TRANS/WP.29/GRSP/2004/17
17 September 2004

PROPOSAL FOR DRAFT AMENDMENTS TO THE 06 SERIES OF AMENDMENTS TO
REGULATION No. 14

(Safety-belt anchorages)

Transmitted by the expert from the European Association of Automotive Suppliers (CLEPA)

Figure 11: ALTERNATIVE METHOD OF LOCATING THE TOP TETHER ANCHORAGE USING THE "ISO/F2" (B) FIXTURE, ISOFIX ZONE - SIDE, TOP AND REAR VIEWS"

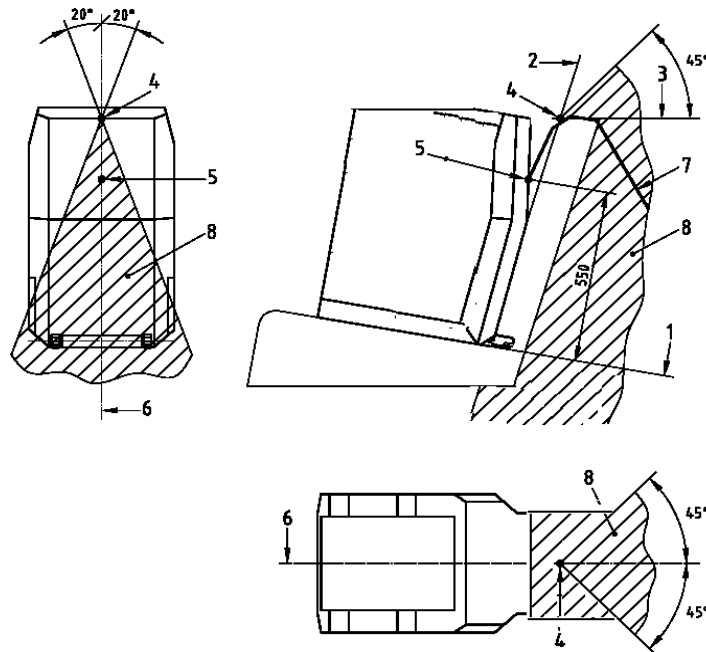
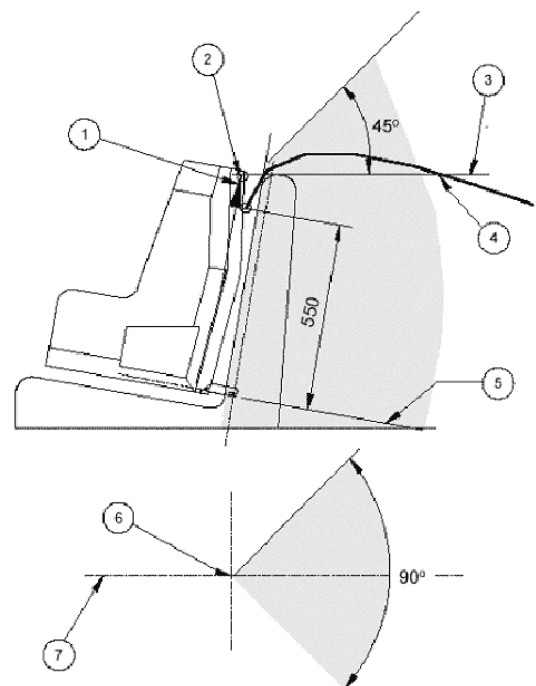
"5.2.4.2. The ISOFIX top tether anchorage zone may be alternatively located with the aid of the Fixture "ISO/F2" (B), as defined in Regulation No. 16 (Annex 17, appendix 2, figure 2), in an ISOFIX position equipped with ISOFIX low anchorages as shown in figure 11 of Annex 9.

~~In the side view, the ISOFIX top tether anchorage shall lie behind a lateral plane containing the Fixture "ISO/F2" (B) vertical reference line and below a lateral plane passing through the intersection of the "ISO/F2" (B) fixture reference line and the plane containing the underside of the seat top bar, and extending rearward at an angle of 45° above the horizontal.~~

~~In the plan view, the ISOFIX top tether anchorage zone shall lie between the planes extending rearward and laterally from the tether reference point, and separated by an angle of 90°.~~ **In the side view, the ISOFIX top tether anchorage shall lie behind the "ISO/F2" (B) fixture rear face.**

The intersection between the "ISO/F2" (B) fixture rear face and the horizontal line (Annex 9, figure 11, reference 3) containing the last rigid point of a hardness greater than 50 Shore A at the top of the seat back defines the reference point 4 (Annex 9, figure 11) on the centreline of the "ISO/F2" (B) fixture. At this reference point, a maximum angle of 45° above the horizontal line defines the upper limit of the top tether anchorage zone.

In the top view, at the reference point 4 (Annex 9, figure 11), a maximum angle of 90° extending rearward and laterally and in the rear view, a maximum angle of 40° defines 2 volumes which limit the anchorage zone for the ISOFIX top tether.

The origin of the ISOFIX top tether strap (5) is located at the intersection of the "ISO/F2" (B) fixture with a plane 550 mm distant above the "ISO/F2" (B) fixture horizontal face (1) on the "ISO/F2" (B) fixture centreline (6).

Further, the ISOFIX top tether anchorage shall be more than 200 mm but not more than 2000 mm from the origin of the ISOFIX top tether strap on the rear face of the "ISO/F2" (B) fixture, measured along the strap when it is drawn over the seat back to the ISOFIX top tether anchorage."

The construction zone described today in paragraph 5.2.4.2. and on figure 11 of Annex 9 is not very clear.

The following points, which are essential for the construction of the zone, are not explained:

- Position of the seat for the construction of the top tether zone
- CRF vertical reference probe (point 1 in the figure)
- Isofix vertical reference line (described in paragraph 5.2.4.2.)
- Top tether reference line (point 2 in the figure)
- Horizontal line (point 3) and plane containing the underside of the seat top bar (described in paragraph 5.2.4.2.)
- Tether reference point (point 6 in the figure)
- How the line limiting the top tether zone at 45° is constructed

The modification of paragraph 5.2.4.2. and figure 11 of Annex 9 would provide such clarifications.
